Re: In the Matter of PORTLAND GENERAL ELECTRIC COMPANY,
2019 Integrated Resource Plan
Docket No. LC 73

In the Matter of)	
)	
PORTLAND GENERAL ELECTRIC)	OPENING COMMENTS OF THE
COMPANY,)	ALLIANCE OF WESTERN ENERGY
)	CONSUMERS
)	
2019 Integrated Resource Plan.)	
_____)

**Comments of Dr. Marc M. Hellman on behalf of the
 Alliance of Western Energy Consumers**

Re: LC 73 - Comments on behalf of AWEC on the 2019 Integrated Resource Plan of Portland General Electric Company

Figure 2.5-1. Technology Maturity Model

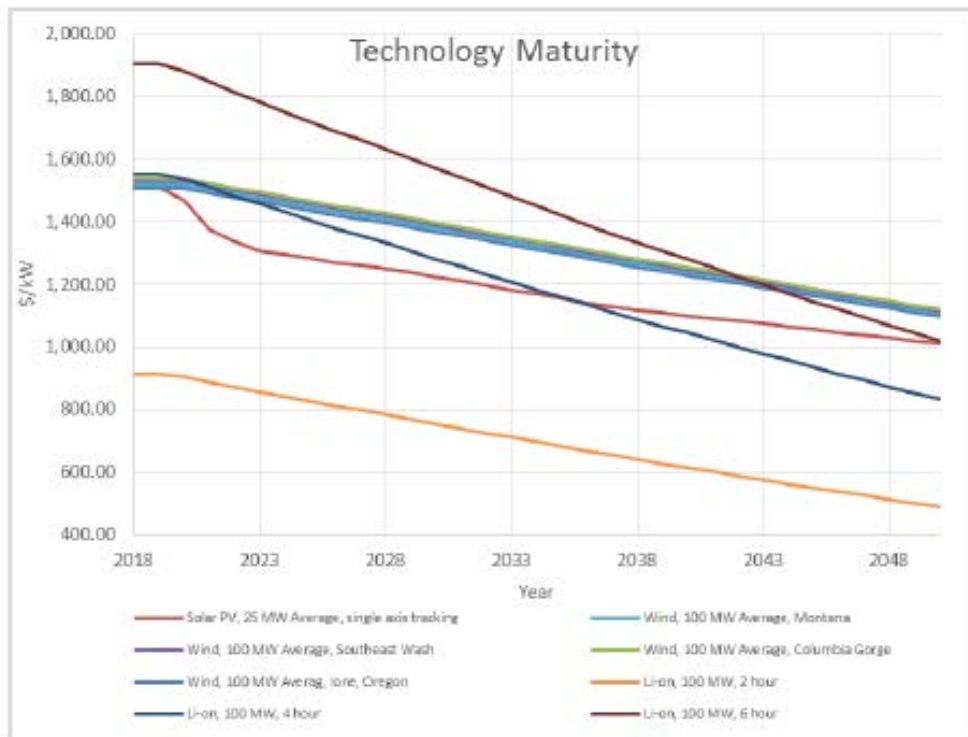
This can be seen from Figure 2.5-1 on Page 10 of the HDR Project on Renewables and Battery Supply Side Options. A change from \$1400/kW in 2028 to \$1200/kW in 2043 represents an annual one percent reduction in 2018 dollars cost per kW.

PGE's assumption of a one percent decrease in the constant dollar installed cost of wind resources understates technological progress. Other sources reporting on wind economics, such as the 2018 USDOE Wind Technologies Report, provides data that shows technological progress to be much greater than 1 percent per year.^{3/} And while installed cost per kW is meaningful, the ability to capture greater energy at the same or lower wind speeds also affects the technological progress. Therefore, in addition to considering changes in installed cost over time, expected MWH generation also needs to be analyzed to capture improvements in turbine design.
